Subject: Riverbank Filtration (RBF) Tunnel and Pump Station
Evaluation of Proposed Bridge Pier Location

Subject: Evaluation of the Impact of Bridge Piers on RBF Tunnel

Project: LWC Riverbank Filtration Tunnel and Pump Station (02223.007)

Subject: Evaluation of the Impact of Bridge Piers on RBF Collector Well Screens

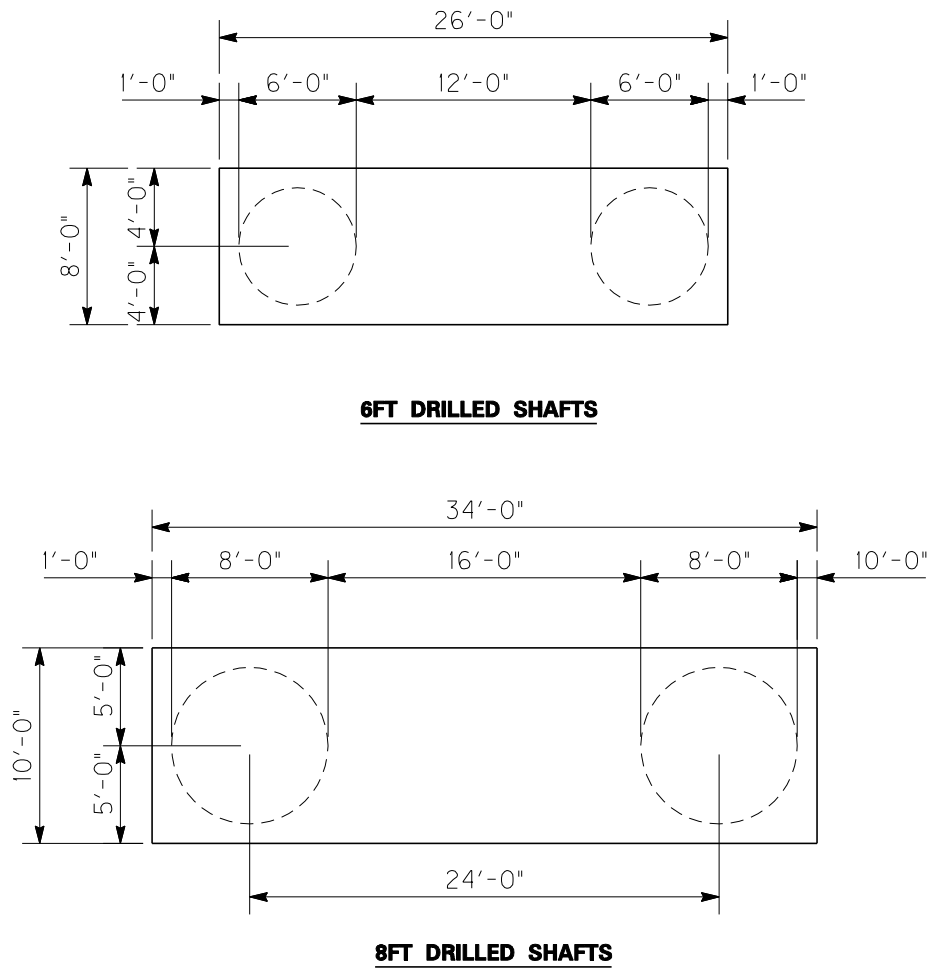
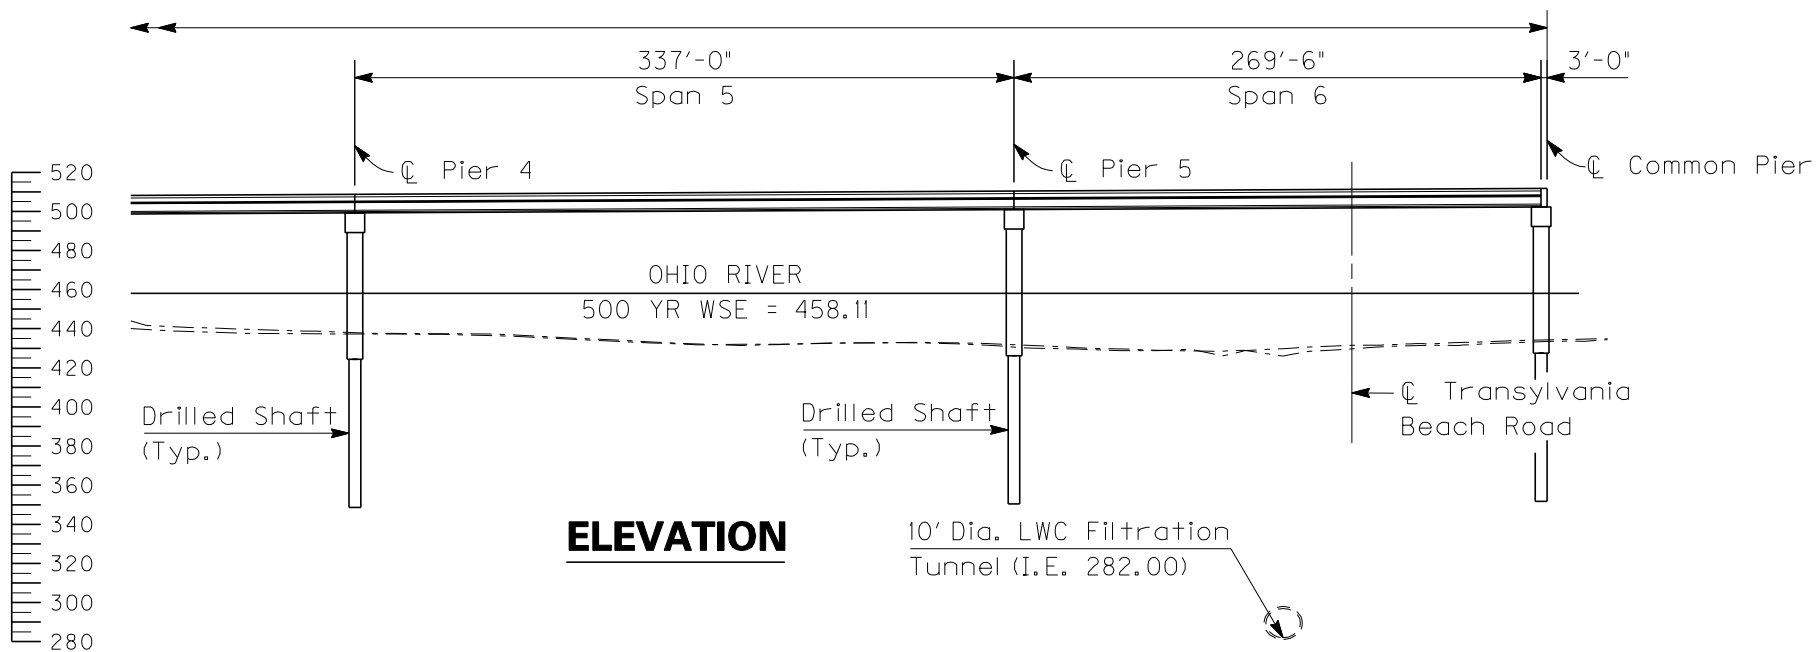
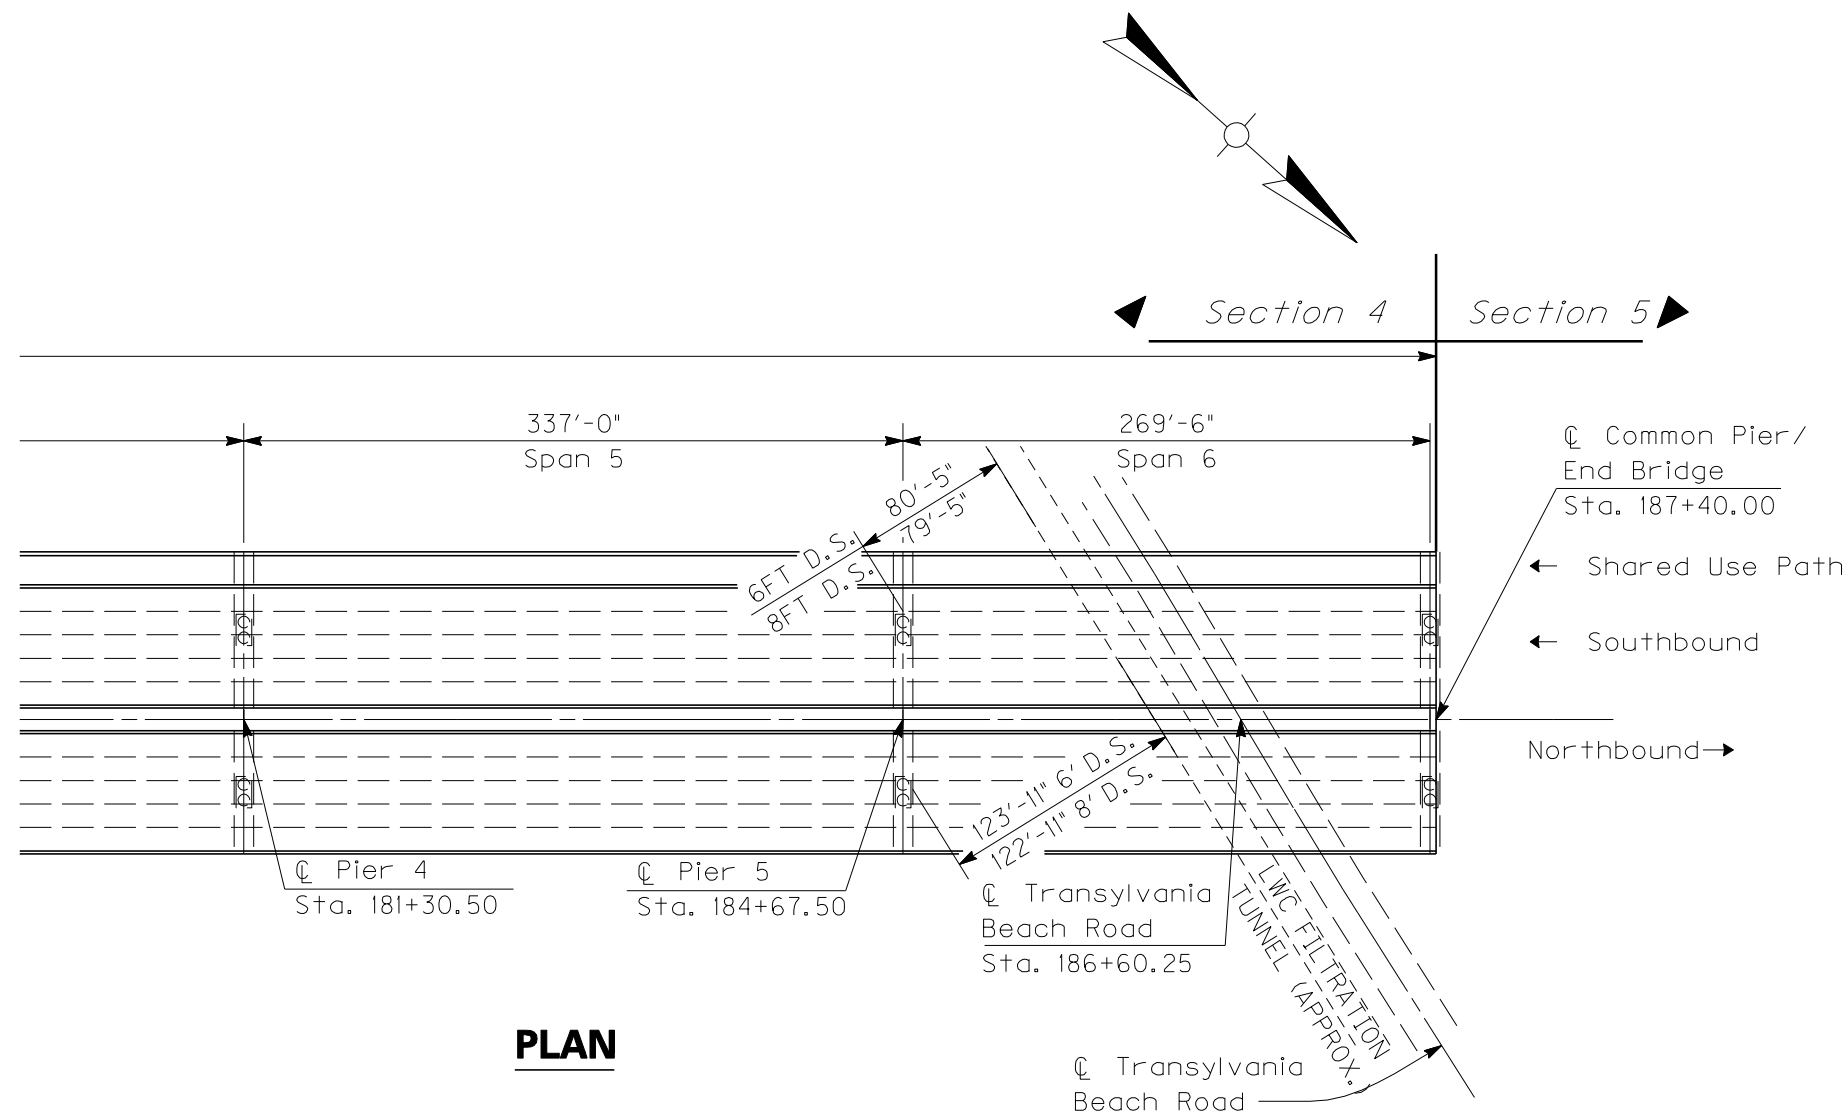
Bridge Option	Distance Piers to Tunnel (ft)	Pier Loads (ksf)*	Equivalent Stripe load (ksf)	Piers' Impact on Tunnel			
				Bending (kip-ft)	Tensile (psi)	Thrust (psi)	Shear (psi)
8 Span	20	83	21	0.48	29	34	6
7 Span	42	90	23	0.37	22	24	4
6 Span	80	101	25	0.03	1.8	3	0.3

RECOMMENDED DISTANCE FROM THE PIER TO TUNNEL

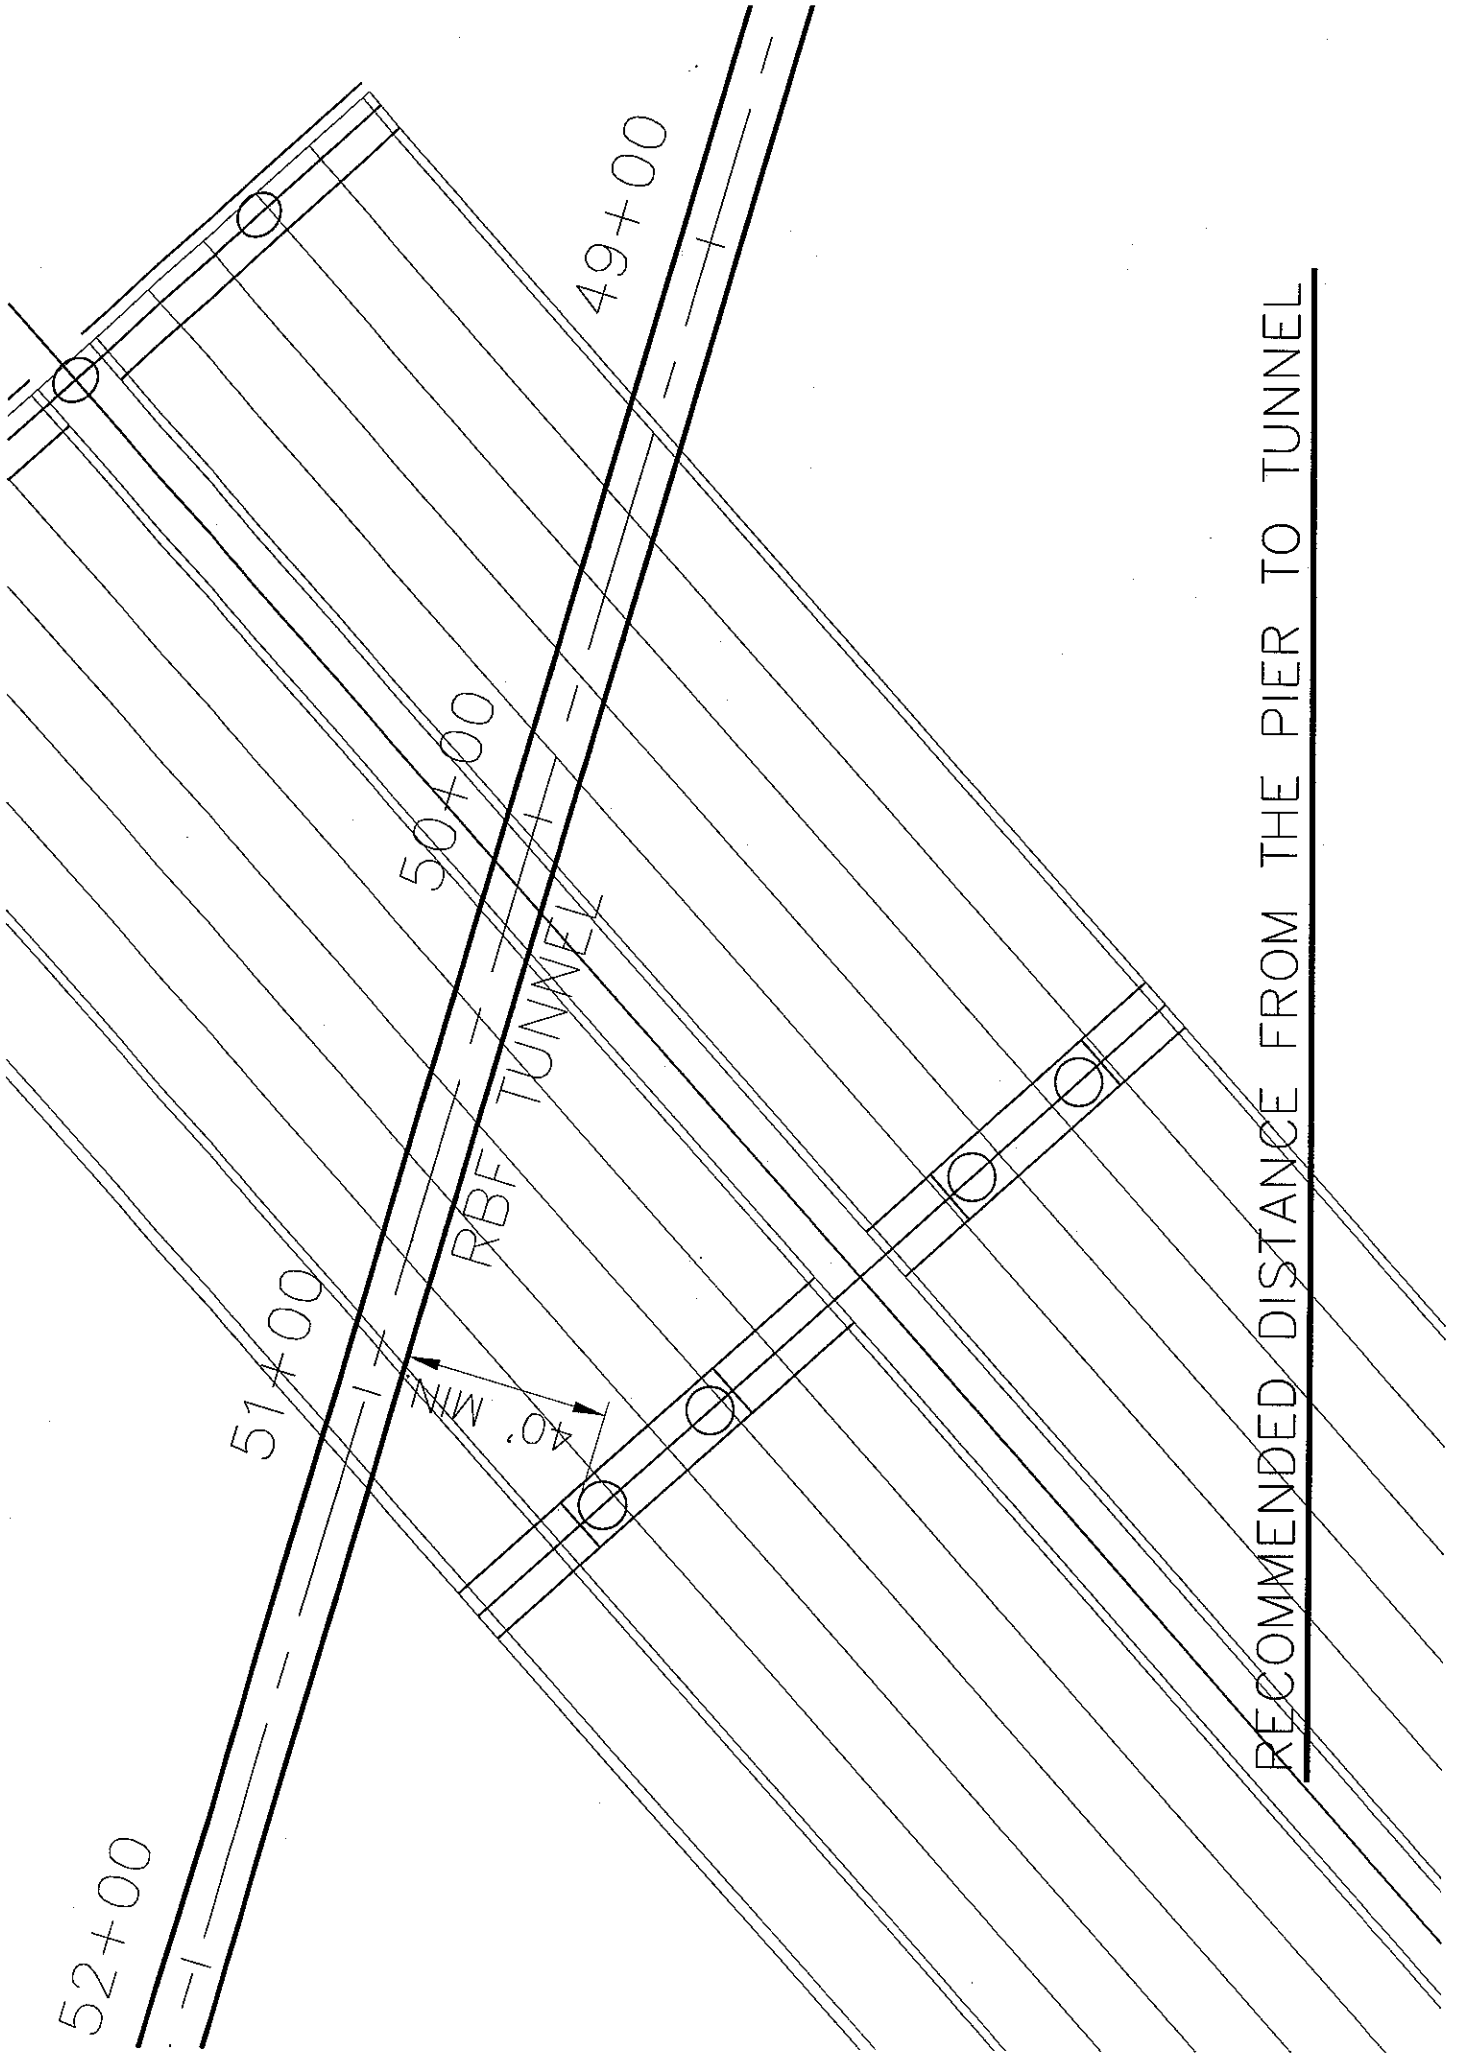
The results indicate that the impact on the RBF tunnel from the bridge pier foundation appears to be minor for the three options proposed by H.W. Lochner Inc., based on the estimated rock properties and the derived equivalent stripe load. However, given the level of accuracy using this simplified analytical method and possible variations in geotechnical properties of the bedrock, we recommend that the bridge piers be located at least 40 feet away from the tunnel in the horizontal direction, as shown on the attached sketch.

Based on the results of our evaluation, we recommend that all bridge piers be located a minimum of 40 feet away from the tunnel in the horizontal direction. Additionally, the design needs to stipulate that no drilling fluids shall be used for construction for any pier shaft within 400 to 500 feet for bentonite and 1,000 feet for polymer fluids (both distances are in the horizontal direction from the end of the downriver lateral in Collector Well No. 3).
